PLANNED UNIT DEVELOPMENT & SURDIVISION STAFF REPORT

DEVELOPMENT NAME Government Street Subdivision

LOCATION 706 and 708 Government Street

<u>CONTEMPLATED USE</u> Planned Unit Development Approval to allow a shared access and parking between two building sites, and Subdivision approval to create two legal lots of record from two existing metes-and-bounds parcels.

SITE PLAN

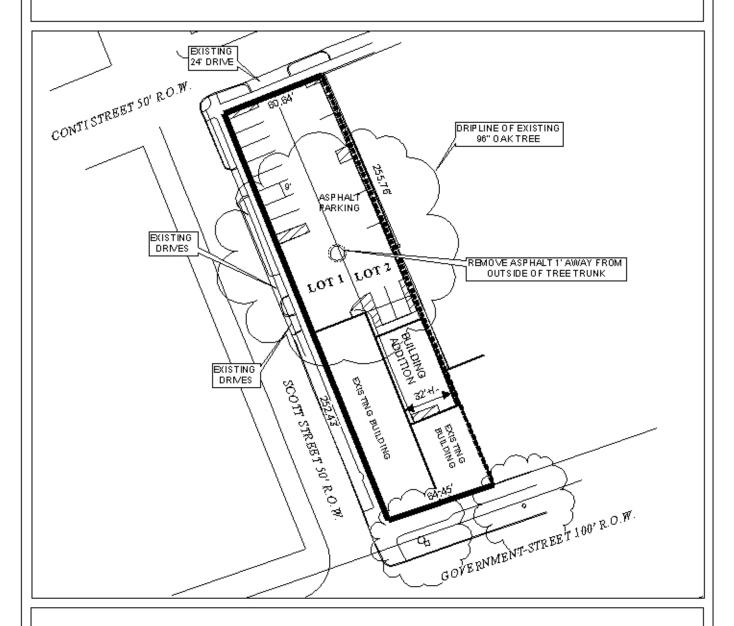
<u>COMMENTS</u> Driveway number, size, location, and design to be approved by Traffic Engineering and conform to AASHTO standards. Close the northern most driveway on Scott Street. Lengthen parallel spaces in the middle to twenty-three feet.

There are problems associated with the proposed parking plan for the site. Internal parallel parking stalls on the East side are indicated to be 20' long as opposed to the 23' minimum required by Traffic Engineering. As there is room along that side to provide compliant parallel parking stalls, the site plan should be revised to indicate such. Along the West side and at the North end of the building addition, no curbing or bumper stops are indicated; therefore the site plan should be revised to indicate such. The existing single curb cut toward the North end of the site along South Scott Street should be closed, and the existing double curb cut at the South end of the parking lot along South Scott Street should be reconfigured to a compliant single curb cut of 24' width.

- 3) placement of a note on the site plan stating that compliance with all building and fire codes is required;
- 4) revision of the site plan to provide a minimum 23' length for all internal parallel parking spaces on the East side of the parking area;

- 5) revision of the site plan to indicate curbing and/or bumper stops along the West side of the parking area and at the North end of the proposed building addition;

- 6) elimination of the curb cut along South Scott Street toward the North end of the parking area;
- 7) modification of the double curb cut at the South end of the parking area along South Scott Street to a compliant single curb cut of 24' width;
